DEVIATION REQUEST AND DECISION FORM

Drop Structures

Project Name : Sterling Ranch Sand Creek Channel Construction Drawing Review CDR 20-4
 Schedule No.(s) : 5227301021, 5233309027, 5228000030 & 38, 5233301001 5233301016 &17
 Legal Description : See Exhibit B – Legal Description

A deviation from the standards of or in Section **ECM section 3.3.3 Open Channel Design Standards** of the Engineering Criteria Manual (ECM) is requested for the Sand Creek Channel Design – Low Flow Channel Capacity.

Exhibit A

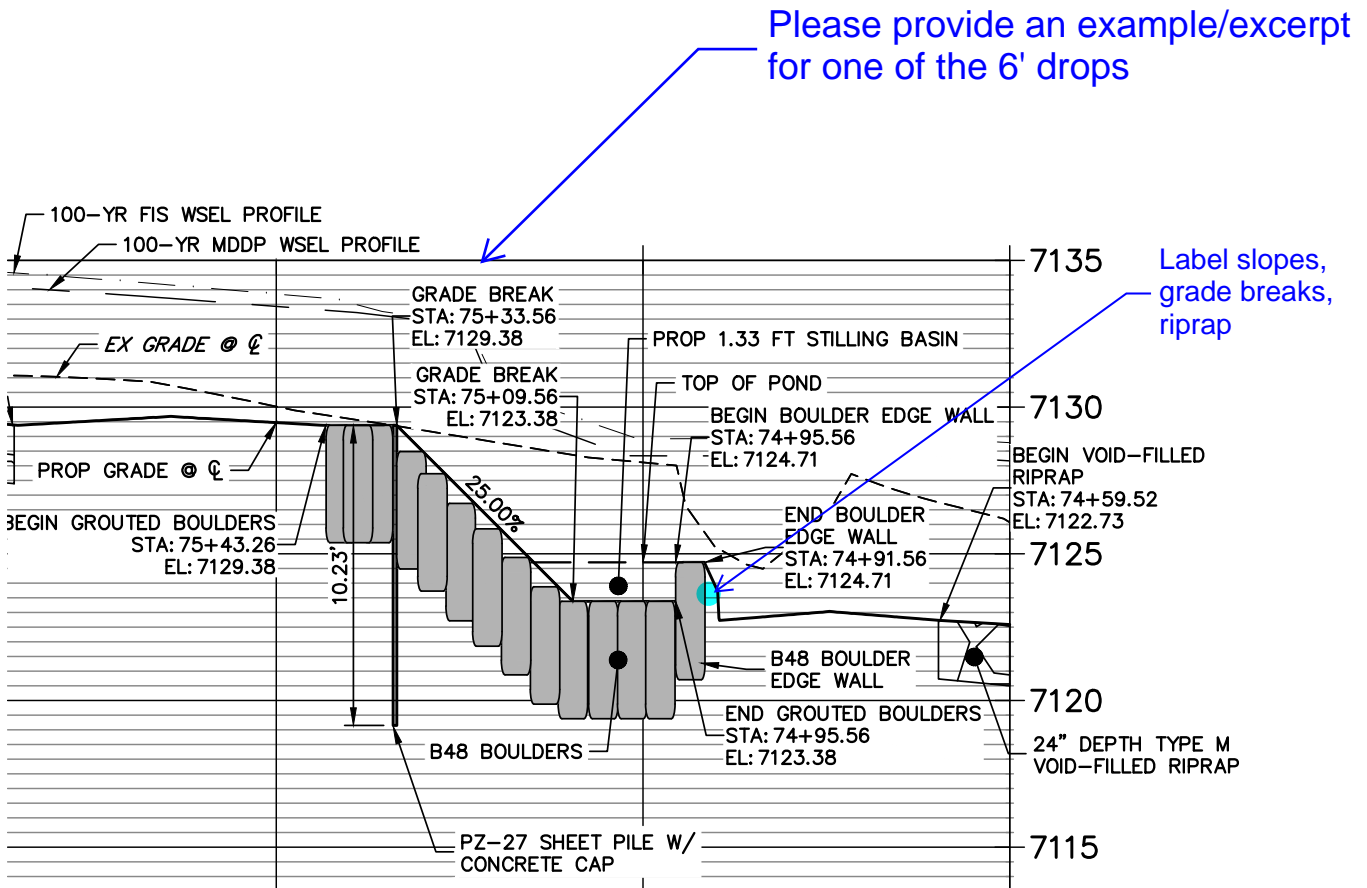
See Exhibit A for a table of the various drop heights used in the Sand Creek Channel plans.

In the design there are 8 grouted boulder drop structures. Seven are typically configured with crest, toe, stilling basin and sill wall and serve to reduce channel longitudinal slope thereby decreasing flow velocities. One drop (GSB #6) is used as a rundown into existing stock pond #2 in the reach above Briargate Parkway and the toe is below the existing water surface, therefore this drop does not require a sill wall.

Drop heights were sized to promote existing wetland preservation. Drop heights in this design are 6 feet or less when measured from crest to toe and 4.7 feet when measured from crest to sill wall of the stilling basin.

The ECM does allow for drop structure heights above four feet if supported by geotechnical investigations and appropriate measures are incorporated into the drop structure design to relieve hydrostatic groundwater pressure on the drop. Each of the 8 drop structures have incorporated a weep hole system to relieve hydrostatic groundwater pressure even regardless of height.

And will be integrated with sheet piling...
